SUB-002723-2023

- Subdivision approval to create one (1) legal lot of record from three (3) metes-and-bounds parcels.

DIVINE MERCY CEMETERY SUBDIVISION

APPLICATION NUMBER 1 DATE December 7, 2023

SITE PLAN

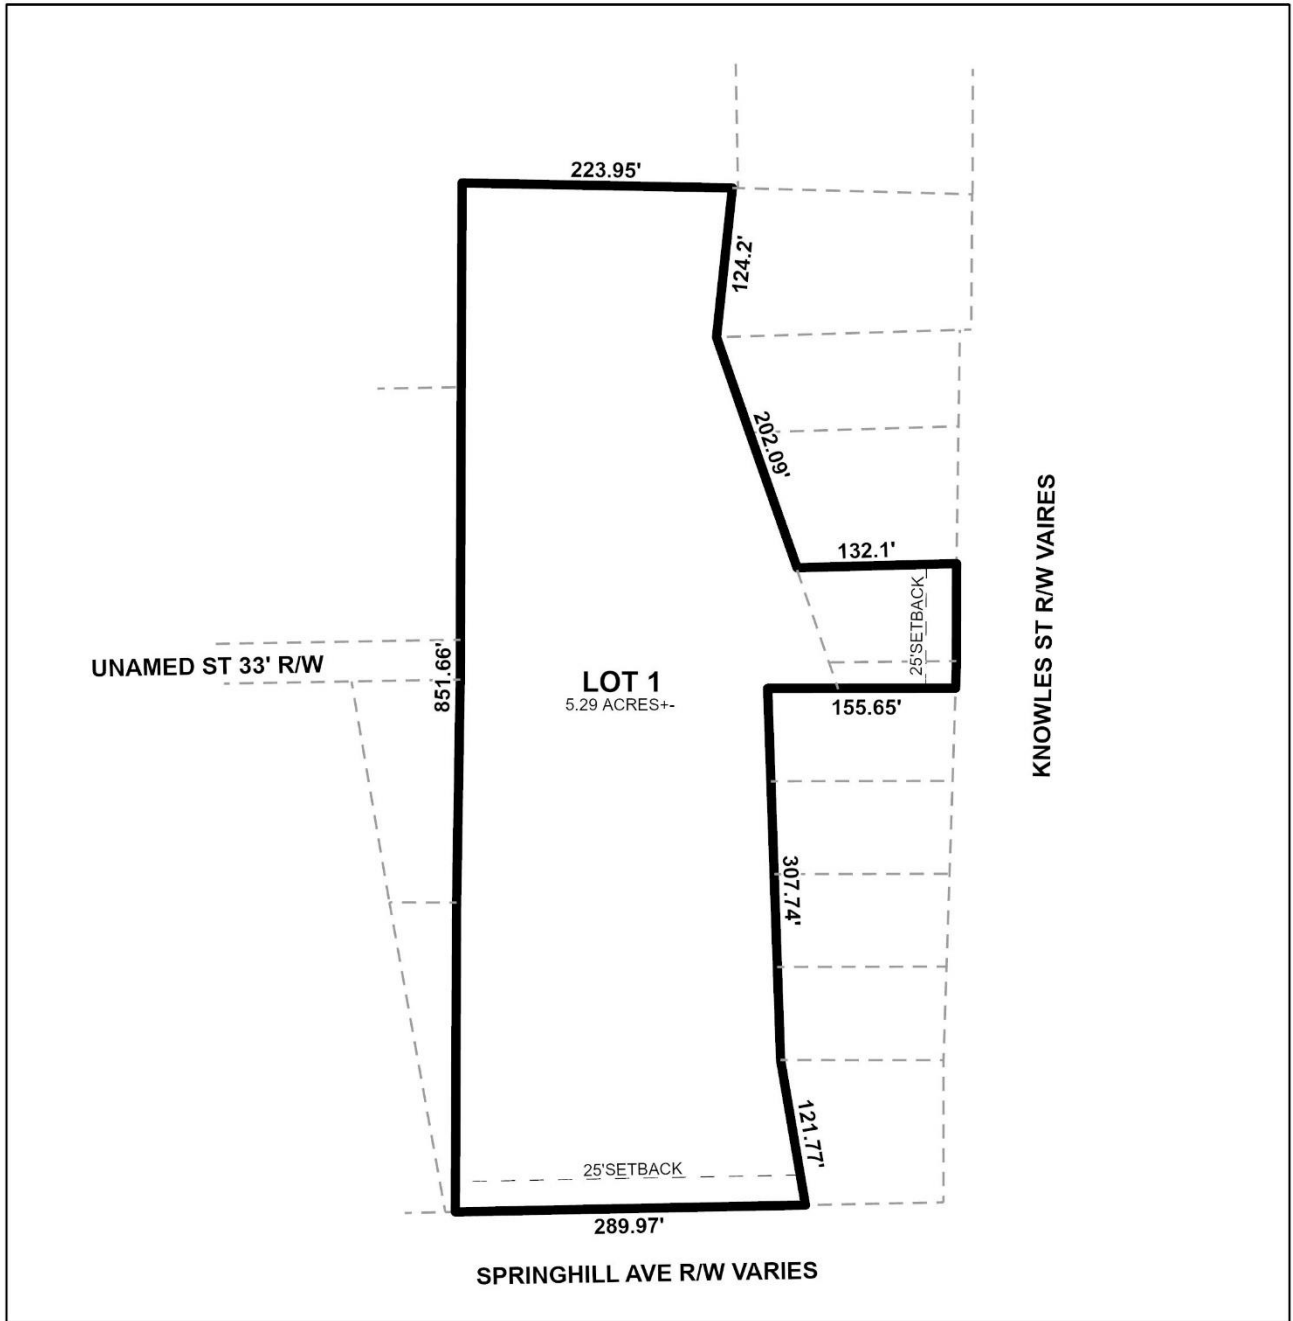
The proposed lots have frontage along Knowles Street, a minor street without curb and gutter requiring a 60-foot right-of-way; and Spring Hill Avenue, a principal arterial street requiring a 100-foot right-of-way. The preliminary plat depicts that the right-of-way varies along both streets at this location. As such, if approved, revision of the plat to illustrate dedication sufficient to provide 30 feet from the centerline of Knowles Street, and 50 feet from the centerline of Spring Hill Avenue should be required.

It should be noted that the preliminary plat incorrectly identifies Knowles Street as "Knowles Street (Lane)." If approved, Knowles Street should be correctly labeled on the Final Plat.

The lot exceeds the maximum width-to-depth ratio of Section 6.C.3. of the Subdivision Regulations by approximately six (6) feet. Considering the proposed lot's depth is not excessively longer than its width with respect to Section 6.C.3., a waiver of this requirement may be appropriate.

A 25-foot front yard setback is illustrated along Knowles Street and Springhill Avenue, in compliance with Section 64-2-5.E of the Unified Development Code. This information should be retained on the Final Plat, if approved, adjusted for dedication.

1. Revision of the plat to illustrate dedication sufficient to provide 30 feet from the centerline of Knowles Street;
2. Revision of the plat to illustrate dedication sufficient to provide 50 feet from the centerline of Spring Hill Avenue;

3. Revision of the plat to correctly label Knowles Street (and not Knowles Street (Lane));
4. Retention of the lot sizes in both square feet and acre on the Final Plat, or provision of a table on the Final Plat with the same information, adjusted for dedication;

5. Retention of setbacks as shown on the preliminary plat, adjusted for dedication;
6. Compliance with all Engineering comments noted in this staff report;
